Consultant Wahib Medanat Consultant Engineers Rep No. QC-23 15

Site Name Jumana Bint Abi Taleb Basic Mixed - Marka Date 12 / 02 / 2022

Package Package 2

Contractor Dijlah Est. Construction Co.
Tender No. 10/2019/USAID/SKEP/3/2

Leakage at the ceiling of the multi-purpose hall

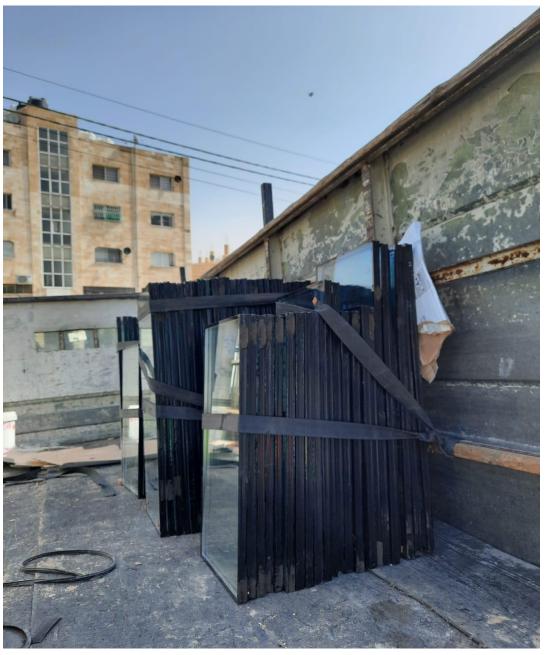
2. Teething of porcelain floor tiles at multi-purpose hall and corridor.	2. Rectify.	
3. Corrosion in the steel protection screens.	3. Maintain.	
 4. Defects in aluminum/window jambs: Jambs should be completely finished before aluminum installation. Lab test of aluminum does not comply. 5. Water penetration test failed for the roof of the multi-purpose hall. 	4. Remove aluminum not complying with specification and maintain jambs.5. Check and rectify the defects.	
Report Prepared by	Hassan Shaqbua, Supervision Quality Control Manager	
Contractor's Response

* No response to points 1, 2 and 3. * The Contractor reponded to point no. 4. * Partial response to point 5. Notes
